MIL-M-28787/271A
AMENDMENT 1
31 March 1993

MODULES, STANDARD ELECTRONIC

CONVERTER, BINARY/BCD, DIGITAL, KEY CODE RQB

This amendment forms a part of Military Specification MIL-M-28787/271A(EC), dated 12 October 1983, and is approved for use by all Departments and Agencies of the Department of Defense.

FIGURE 25. Power supply filter, input, and output capacitance test circuit for tables XVII, XVIII, and XIX.

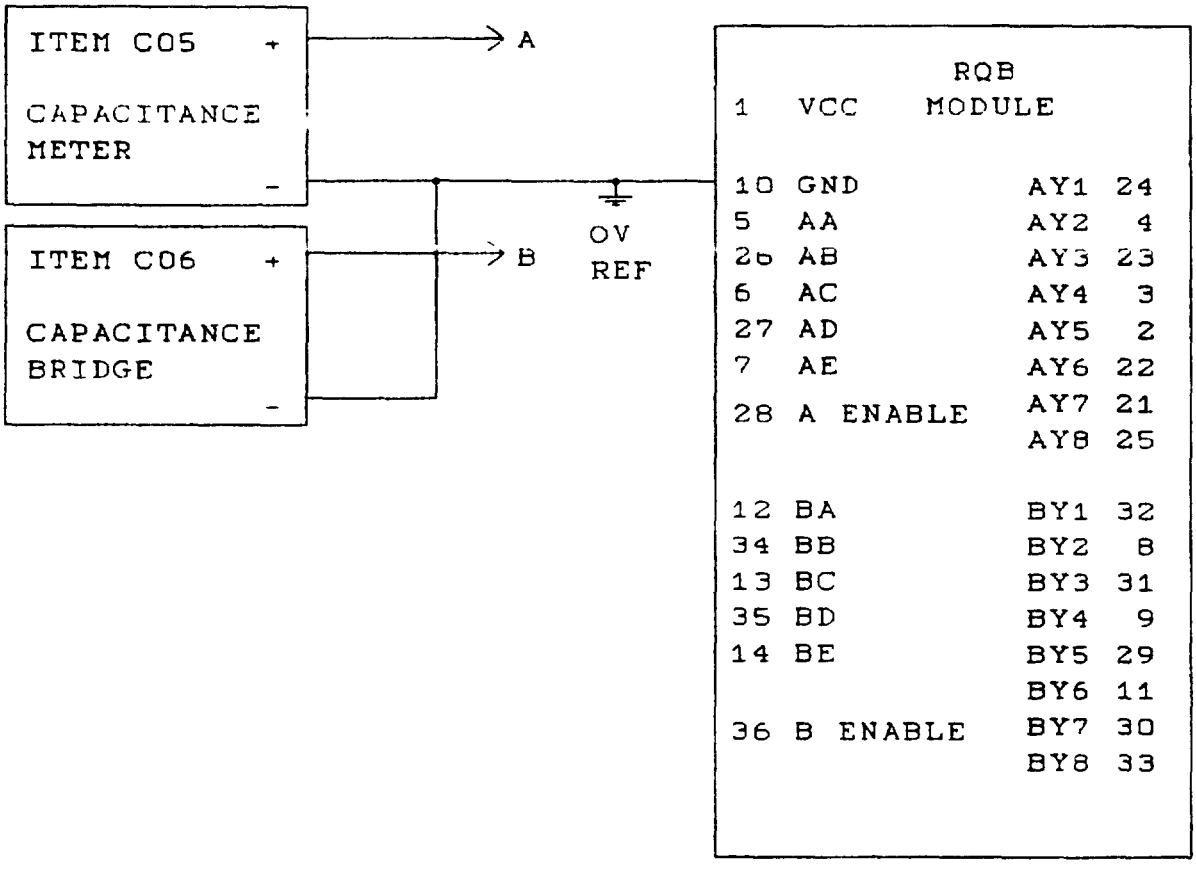
FIGURE 25: Delete and substitute new figure 25 as printed on page 3 of this amendment.

1. **Null out the effects of the test leads prior to connecting the module.**
2. **Do not attach test connectors or wires to any of the module pins other than pin 10 and the pin under test. Stray capacitance added to other pins may affect the readings.**
3. **Item C06 setup:**
   Frequency = 1 KHz.
   V_{ac} = 0.3 V maximum.
